SHOP DRAWING REVIEW

The Kilpatrick Renaissance - Submittal 71B

Item: 1st Floor Cabinetry

1BR_UNIT3

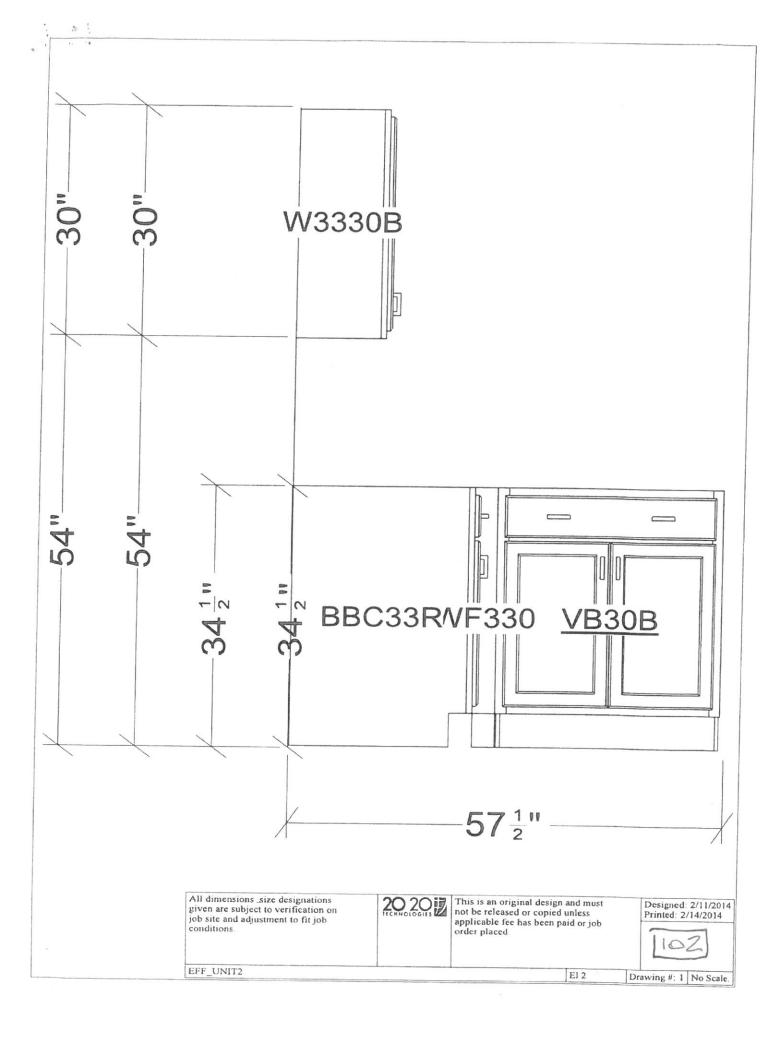
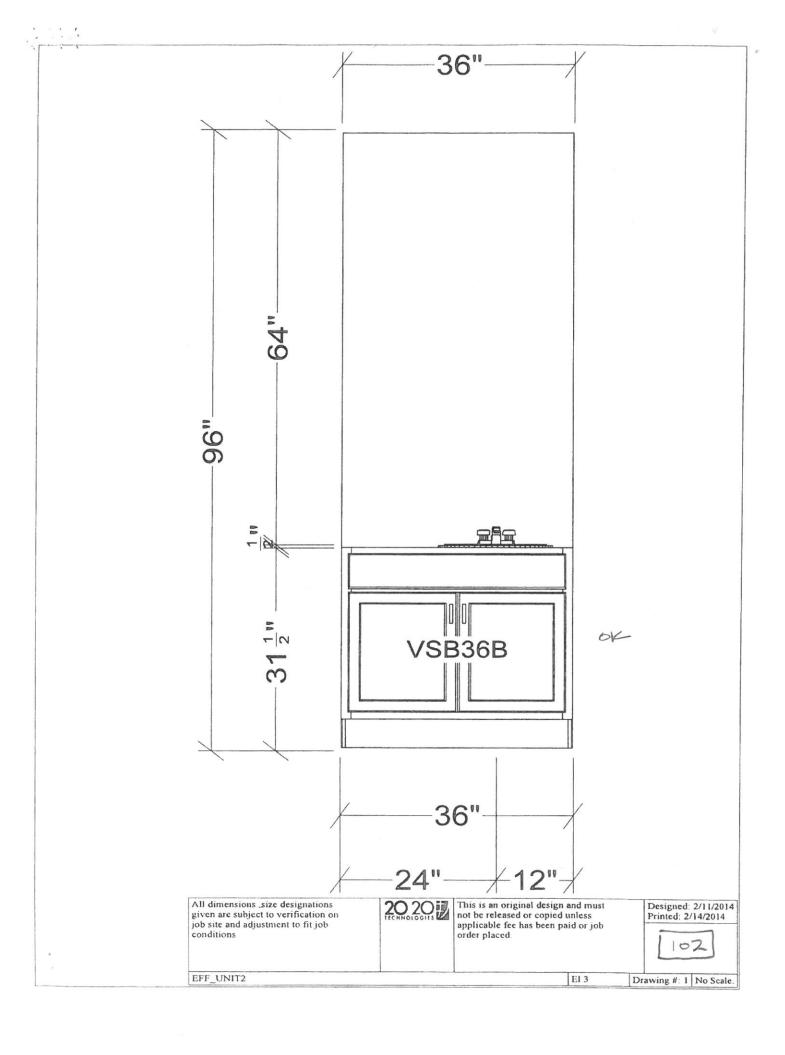
WHIP IS TOO FAR OPE AT LICHT OVER SINC

EFF_UNIT2

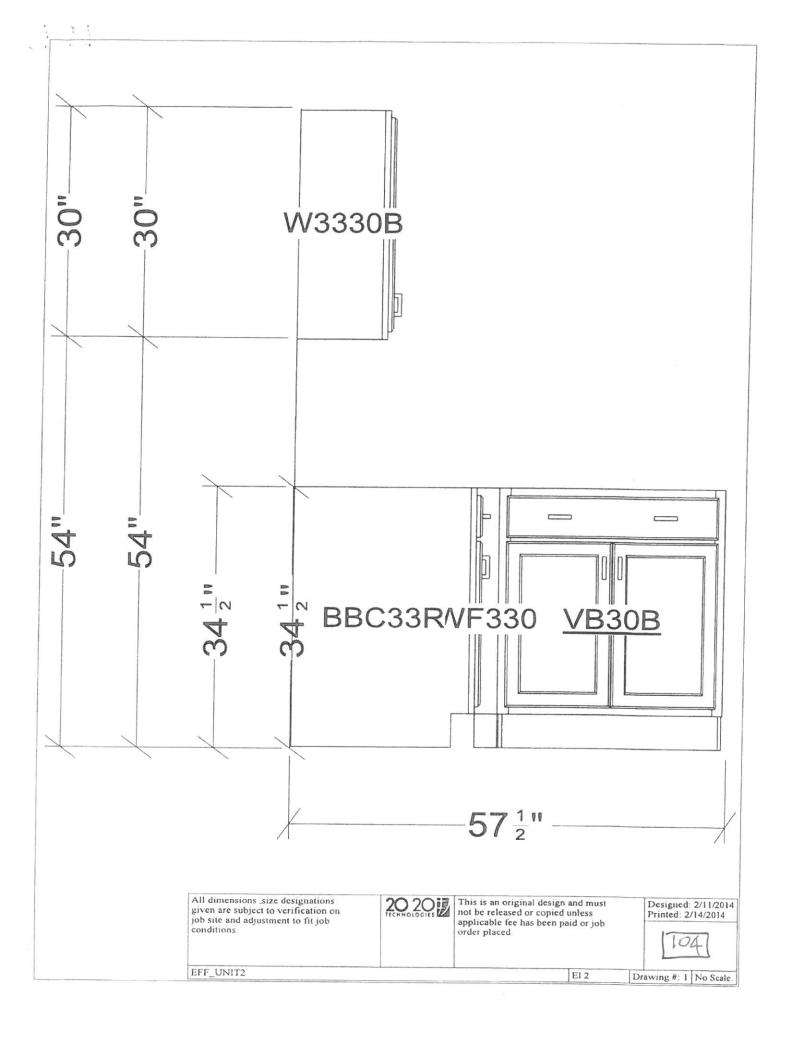
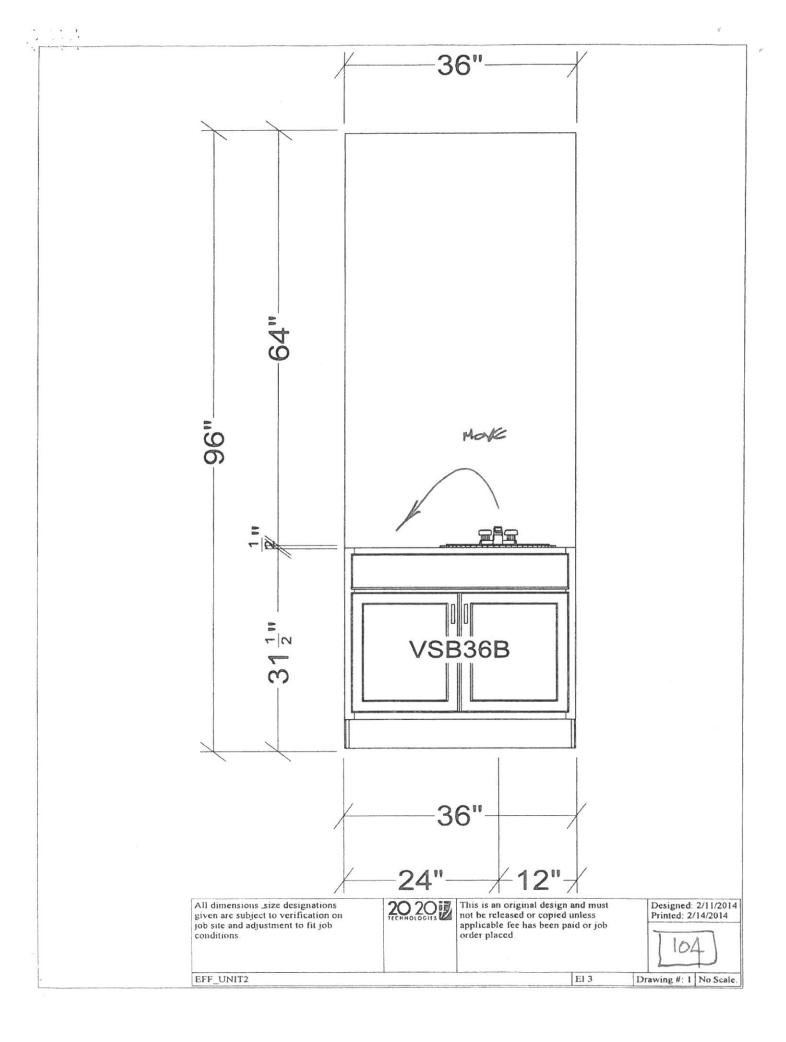
VORIFY LIGHT WHIP

ACTAIL UNIT LAYOUT 15 opposite HAND

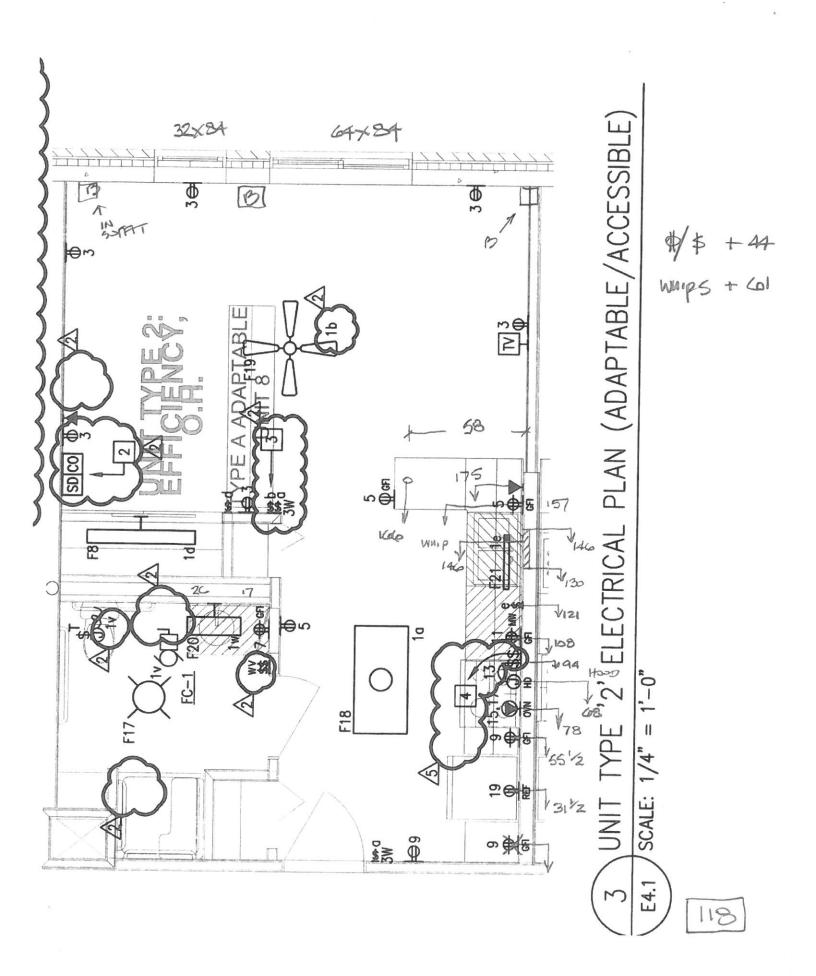
Provide finished end panel on wall cabinet in addition to finished back panel on base cabinets at peninsula.
